TECHNICAL SERVICE BULLETIN

Non-Hybrid - Radio Static And/Or Poor Radio Sound Quality When Moving

24-2043

Ford 2020-2024 Explorer
Lincoln 2020-2024 Aviator

Figure 1

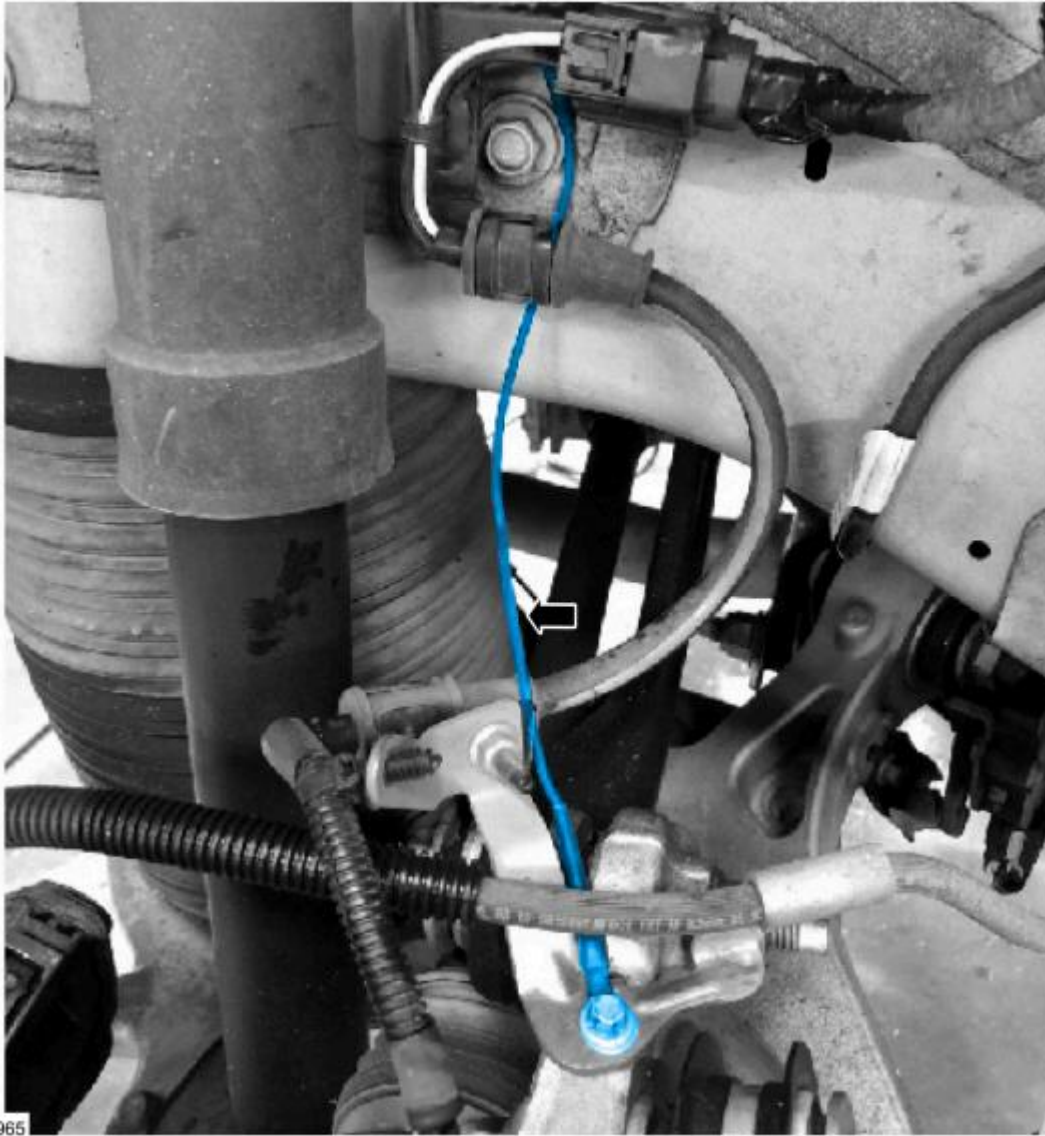
Issue: Some 2020-2024 Explorer/Aviator non-hybrid vehicles may exhibit radio static and/or poor radio sound quality when moving. This may be more noticeable on AM radio stations. This may be caused by an electromagnetic interference concern. To correct the condition, follow the Service Procedure to install new grounds on the rear knuckle.

1. Install new ground straps on each side of the vehicle on top of the brake hose bracket bolt on the rear knuckle. Tighten to 133 lb-in (15 Nm). Refer to Workshop Manual (WSM), Section 204-02. (Figure 1-2)

E375965
Figure 2

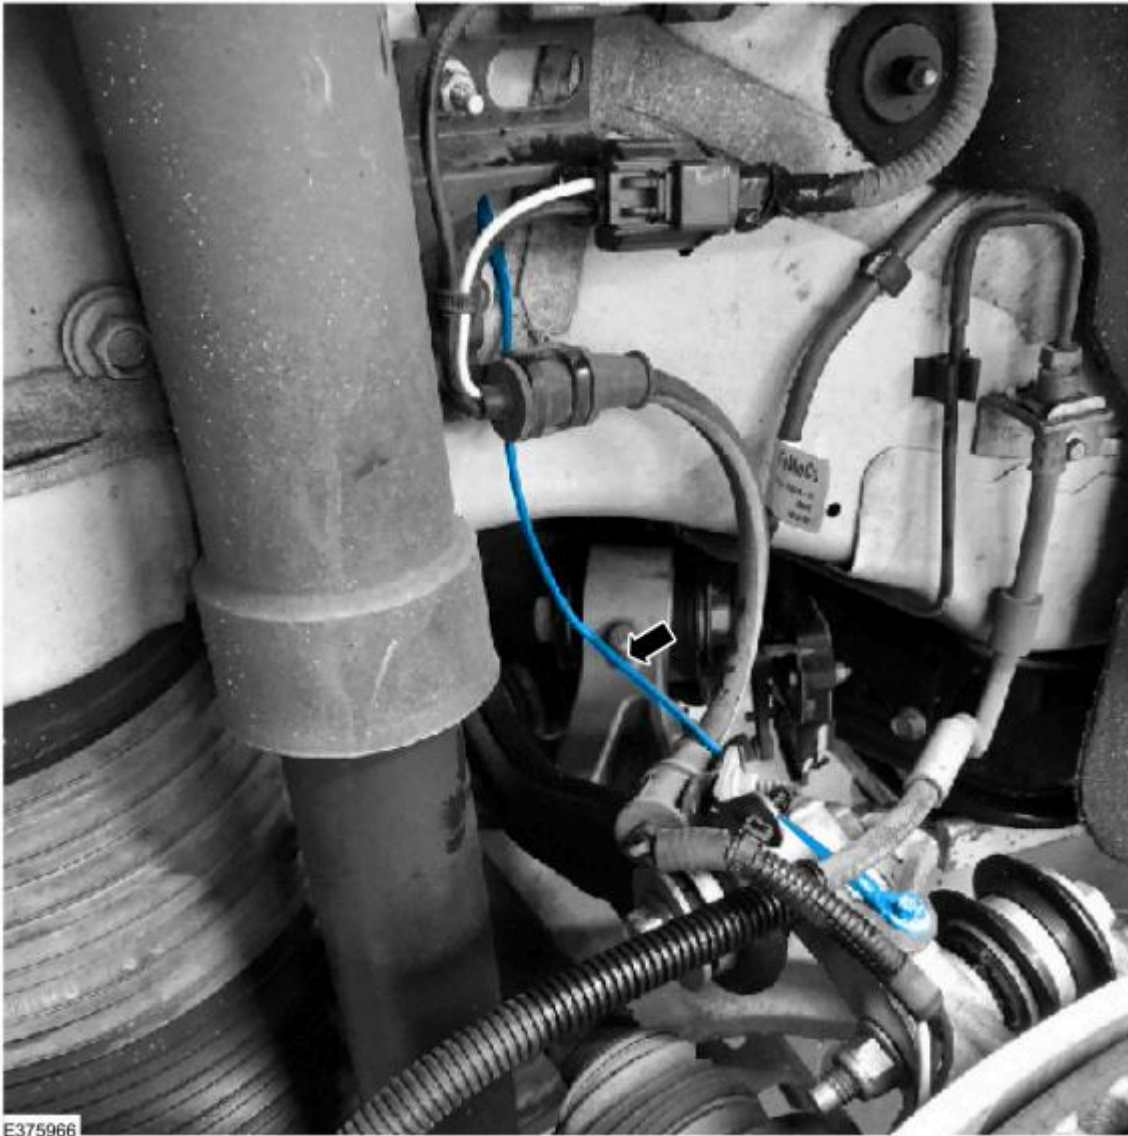
2. Install the other side of the ground straps underneath the rear wheel speed sensor harness bracket mounting stud. Tighten to 62 lb-in (7 Nm). Refer to WSM, Section 206-09. (Figure 1-2)
